CERTIFICATE OF THE SECRETARY OF ENERGY AND ENVIRONMENTAL AFFAIRS  
ON THE  
ENVIRONMENTAL NOTIFICATION FORM

PROJECT NAME : North Allston Storm Drain Extension Project  
PROJECT MUNICIPALITY : Boston  
PROJECT WATERSHED : Charles River  
EEA NUMBER : 16319  
PROJECT PROPONENT : Boston Water and Sewer Commission  
DATE NOTICED IN MONITOR : February 10, 2021

# Charles River Rowing Traffic Pattern

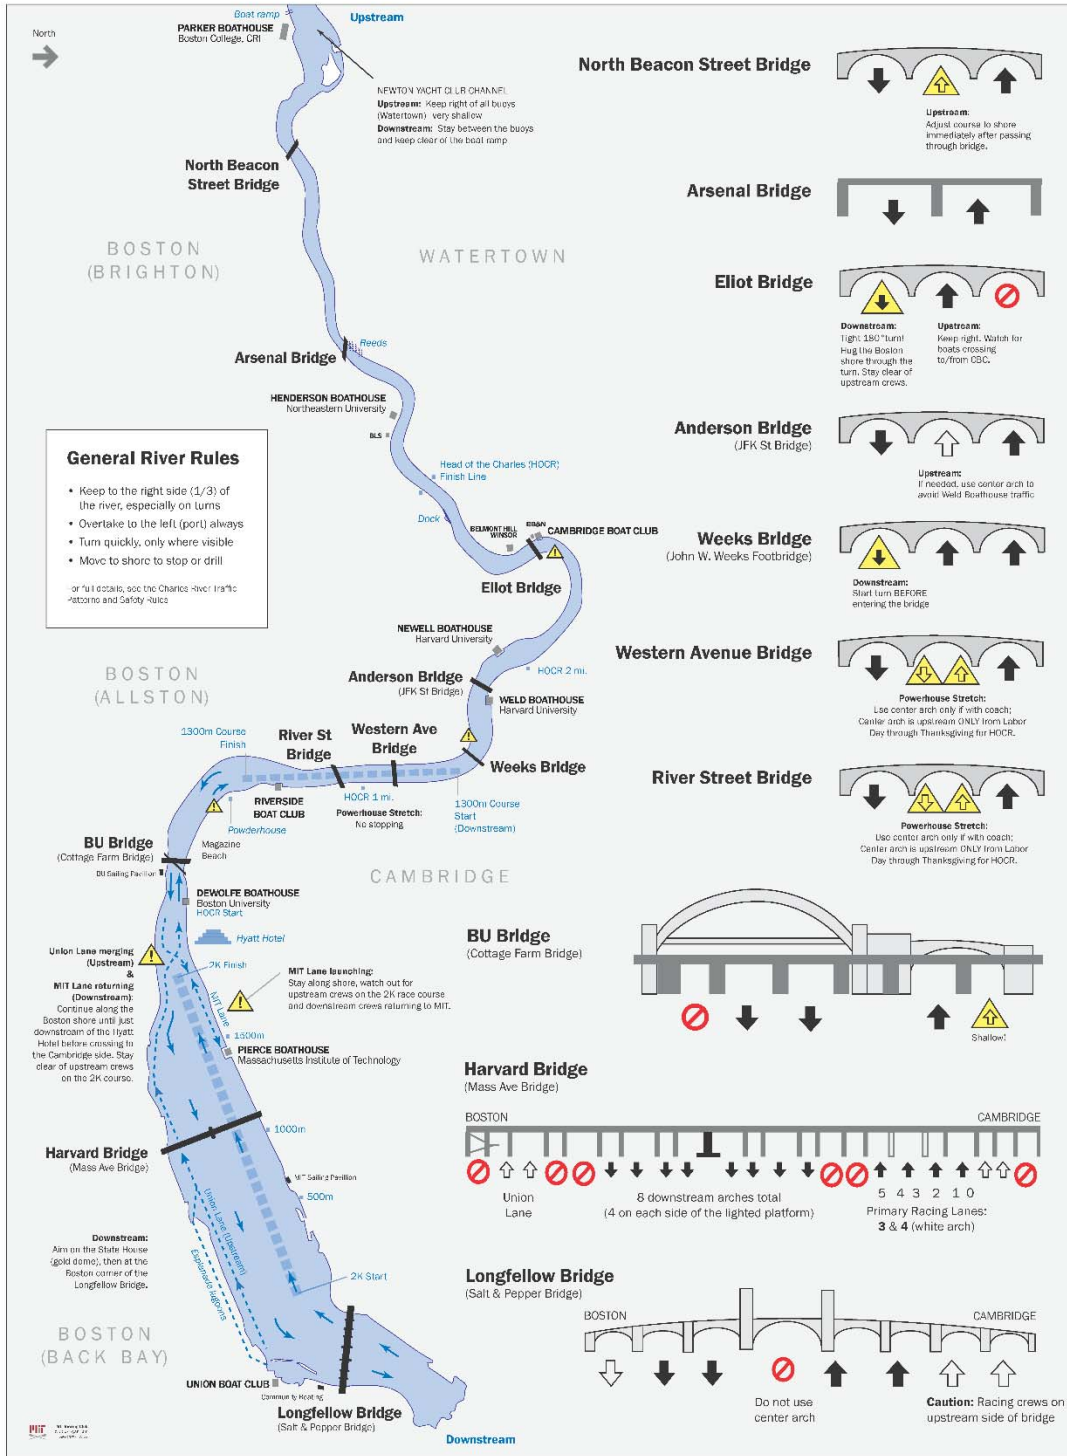
**Existing Site Conditions:** This application would be better served with maps and graphic documentation of the area the catchment would serve and the locations of existing and proposed outfalls. While the description of the location along the river seems expansive as noted at 340 feet wide, it is in fact one of the narrowest and intensely used sections of the Charles River, between Cambridge and Boston, known for its 1300m racecourse as Power House Stretch. It is so narrow, that the regulations for the rowing community are to never stop or turn around in this stretch due to the narrowness and volume of boating and rowing traffic. See attach Charles River Association of Boaters regulations.

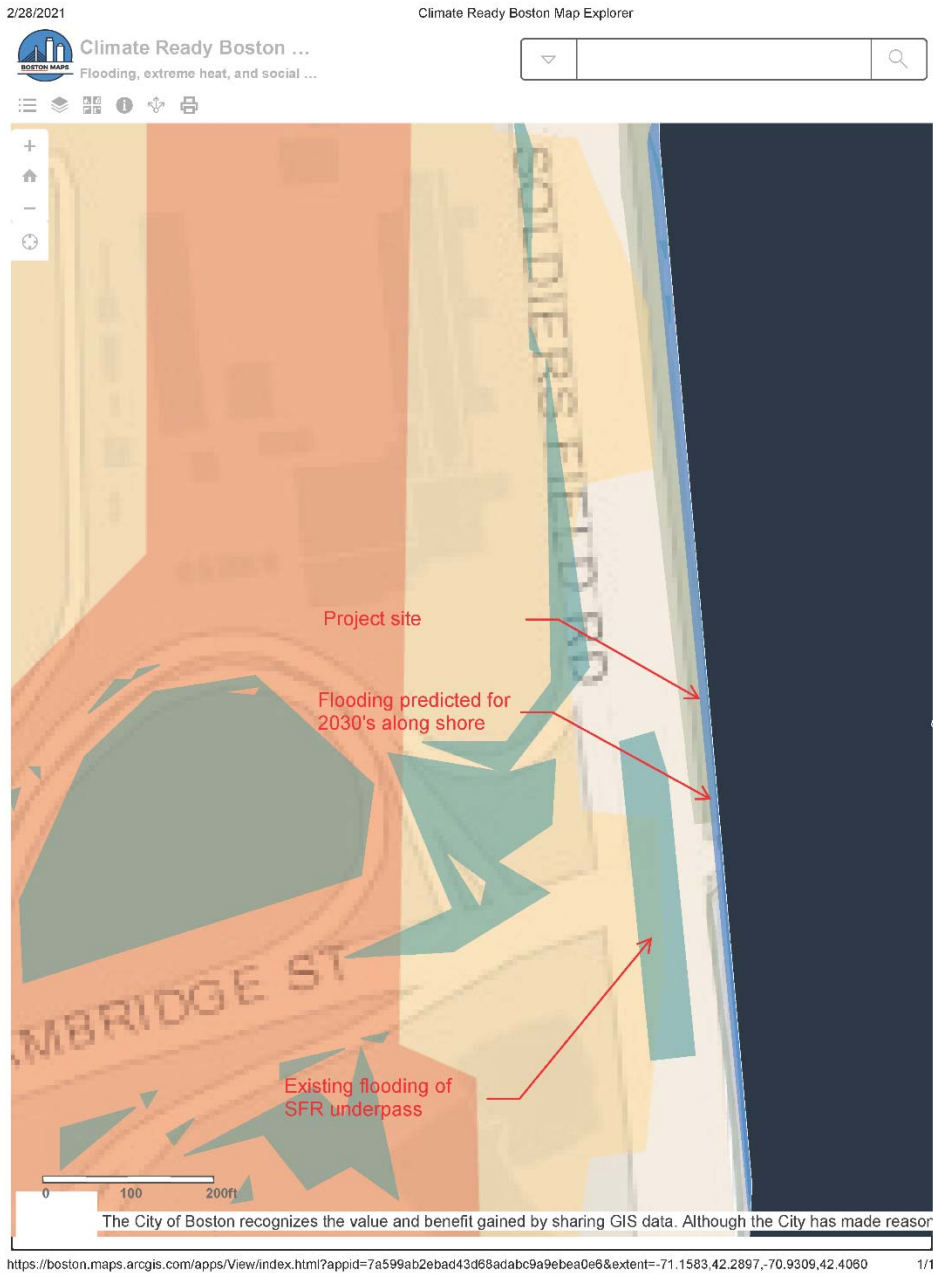
**NASDEP Design:** The modeling was based on the static water level of the Charles River, although as an avid rower, my experience is that the river level is rarely static, and at this date currently at higher levels than standard. During the extent of the pandemic – staffing at the locks has been reduced and water levels have rarely been reduced by opening of the locks. With rising sea levels, lowering the Charles River will not be able to achieved to lower levels as previously done in the past. Review of the Boston Climate Ready map demonstrates that there is already moderate flooding of the underpasses at Soldier’s Field Roadway at Cambridge St and Western Ave, no mention is made that the site as currently proposed will be impacted by flooding by the 2030’s.

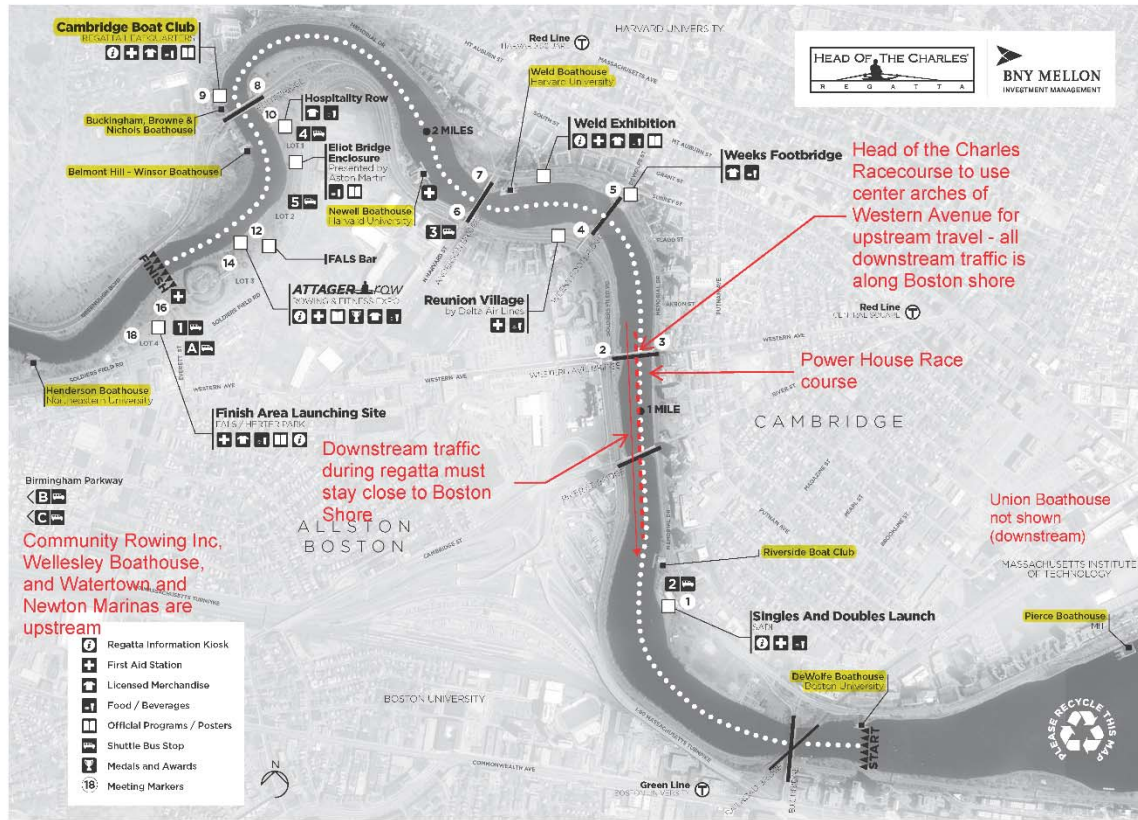
**Construction Information and Schedule:** The crane platform and pile installation of 1,994 SF in the water do not mention the standard practice use of a turbidity curtain, which is intended to extend into the river around the construction area in a 100' radius. This is a huge hazard in the narrowest, most heavily trafficked portion of the river.
